REGION OF OTTAWA-CARLETON  
 RÉGION D'OTTAWA-CARLETON

REPORT  
 RAPPORT

SUBJECT/OBJET                        **PROPOSED PERMANENT SURFACE ENCROACHMENT AT  
 137 MURRAY STREET, OTTAWA**

Cross Section of Murray Street  
at Proposed Encroachment

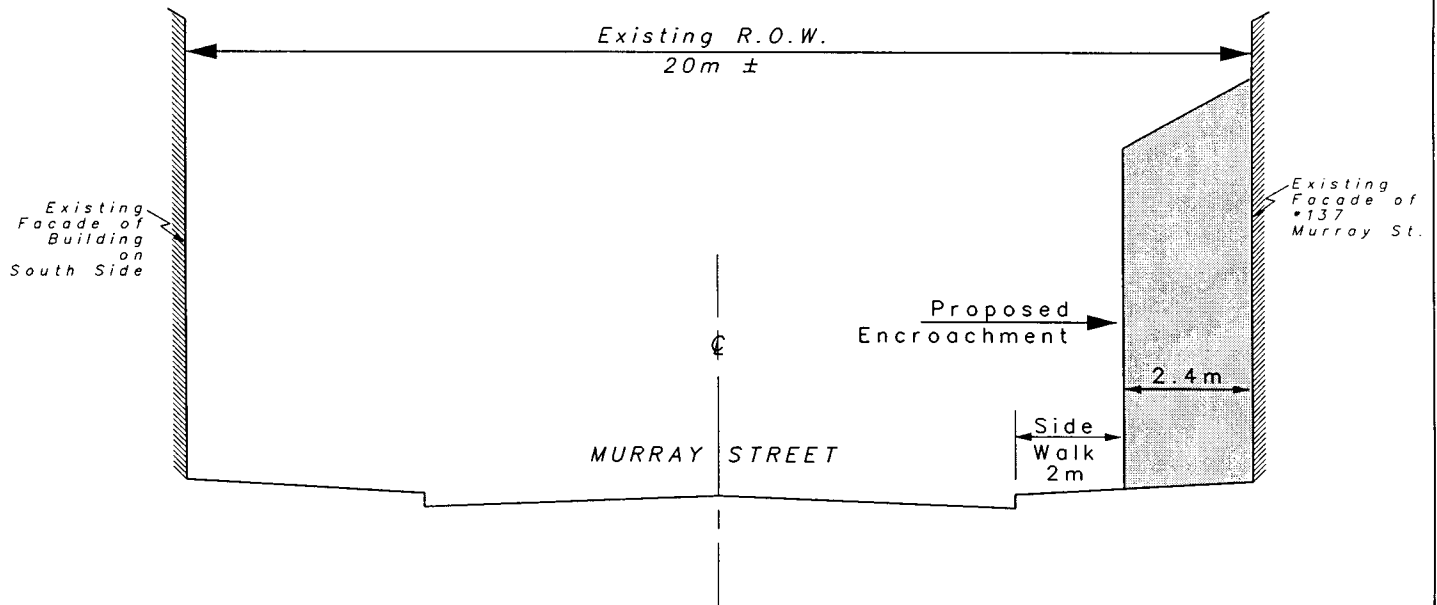
- Under subsection 2.10.1 (8) of the Regulatory Code the proposed encroachment is identified as a ‘*Permanent Surface Encroachment*’.
- Under subsection 9.2.8. a) of the Official Plan, the following environmental guideline for pedestrian facilities on Regional roads is given; ‘*provide a minimum effective sidewalk width of at least 2.0 m with a separation from vehicular traffic in the form of a boulevard of 2.0 m where feasible, and under no circumstances provide an effective sidewalk width of less than 1.5 m*’. Effective sidewalk width is the width remaining after reductions are made to take account of the natural inclination of pedestrians to keep clear of obstructions such as buildings or street furniture, and danger zones such as areas of moving traffic. The effective sidewalk width varies with pedestrian volumes, i.e. the greater the volume the larger the required sidewalk width. The Department uses 0.45 m clearance for obstructions on both sides of the effective sidewalk width to determine the total sidewalk width, with additional clearances for unusual circumstances such as window shopping areas, trees, fire hydrants, parking meters, etc. To give an example, an effective sidewalk width of 1.5 m with two clearance zones of 0.45 m would require a total sidewalk width of 2.4 m.

- The minimum planning requirement on the Urban Cross-Section of the Regional Road System Right-of-Way Requirements Review Study calls for a minimum inner boulevard of 0.5 m with a 1.5 m sidewalk and an outer boulevard of 1 m.

Applying the parameters of the above-mentioned ‘tools’ to the subject application, a minimum distance of 2.85 m from edge of pavement to the wall is required. This includes the additional offset requirement of 0.45 m due to the fact that the proposed encroaching wall has an entrance-door located in it.

Plan View  
at  
Proposed Encroachment

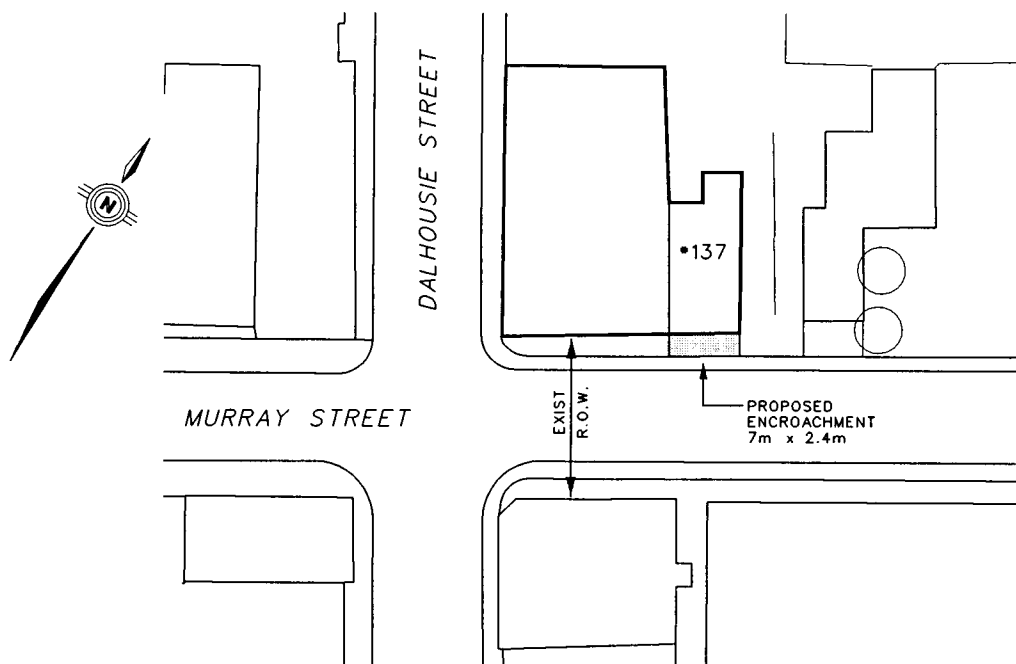
This Department has investigated your request, and come to the conclusion that we cannot recommend that the public road allowance at the subject site be encumbered with the proposed new building addition for the following reasons.

1. Public road allowances are not only used for vehicular traffic. There are many other uses, among these are: pedestrian use, bicycle use and street-scaping (e.g. Somerset Street). The proposed encroachment would severely interrupt a street-scaping program on this section of Murray Street. Pedestrian use is number one in the hierarchy of uses of the public right-of-way in the central area. The proposed permanent encroachment could not provide a pedestrian-friendly environment.
2. It would eliminate the implementation of *a separation from vehicular traffic in the form of a boulevard of 2 metres* as recommended in the Regional Official Plan.
3. Exiting vehicles from the adjacent laneway of the subject site would have insufficient visibility, and become a danger to pedestrians.
4. Winter maintenance operations would also be adversely affected by the proposed encroachment.

P1 PLAN OF ENTRANCE SOLARIUM  
1:50

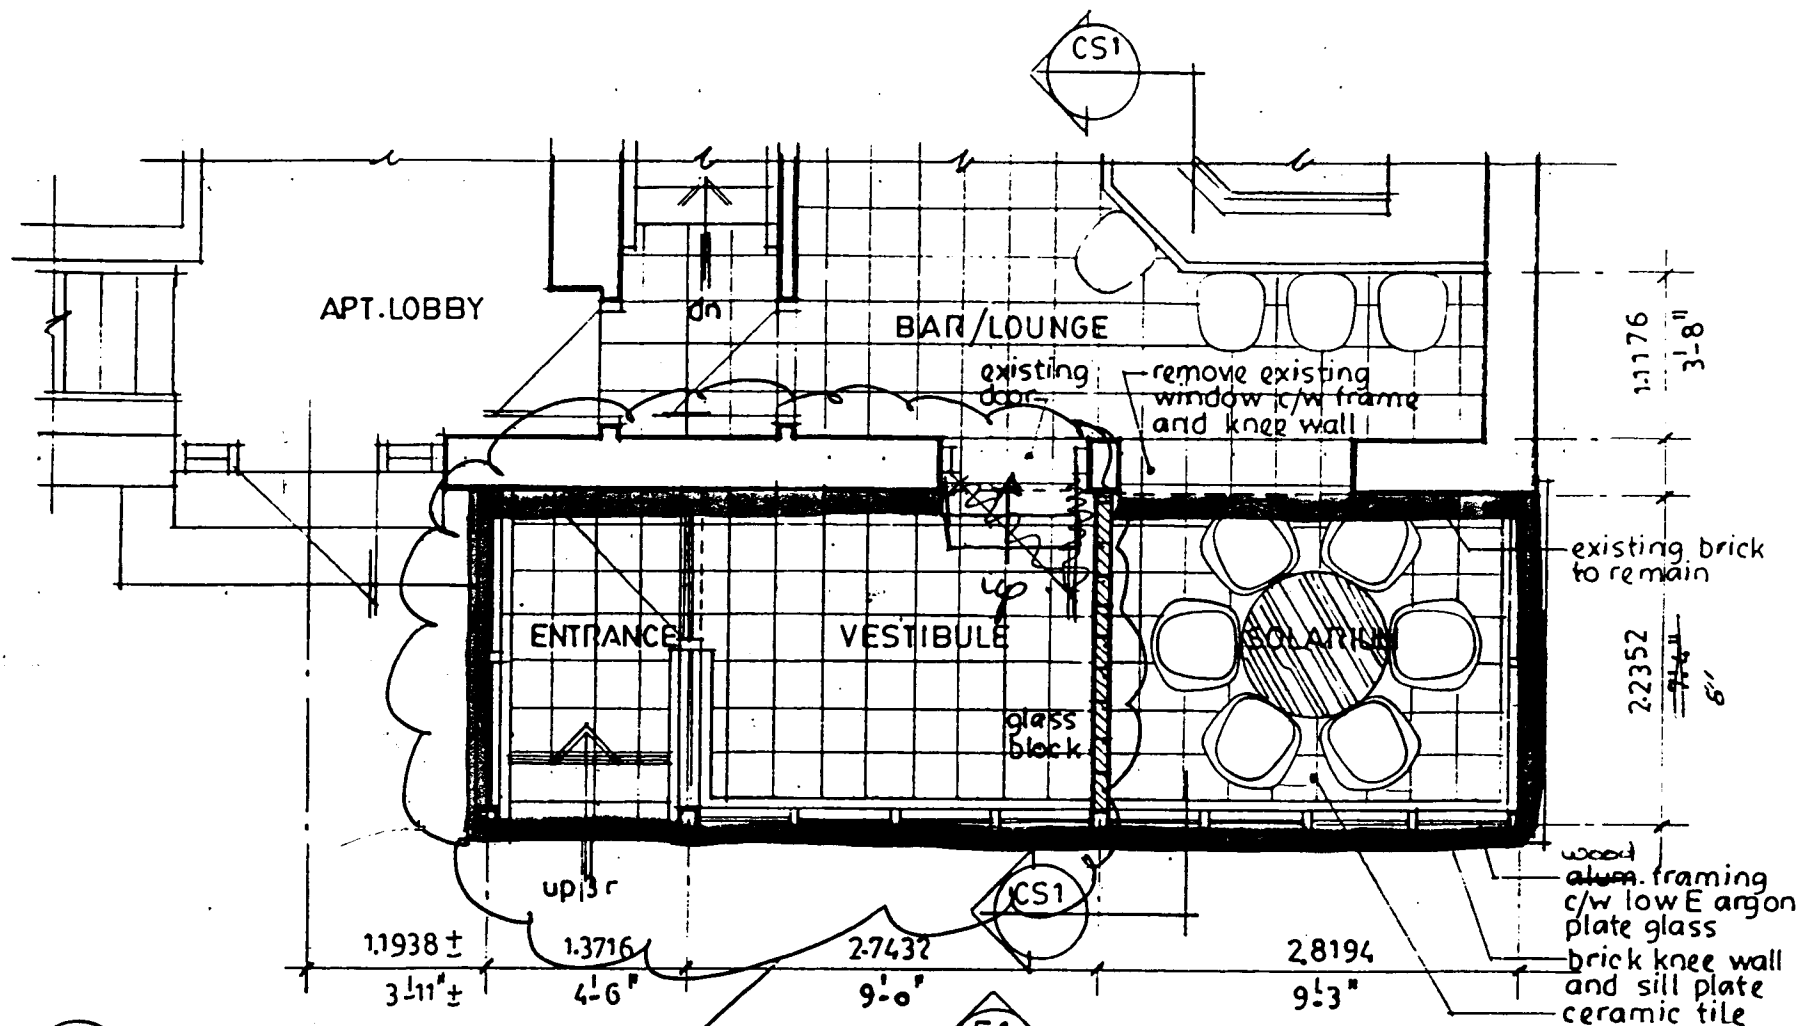
→ vestibule  
shall be  
Barrier-free  
accessible
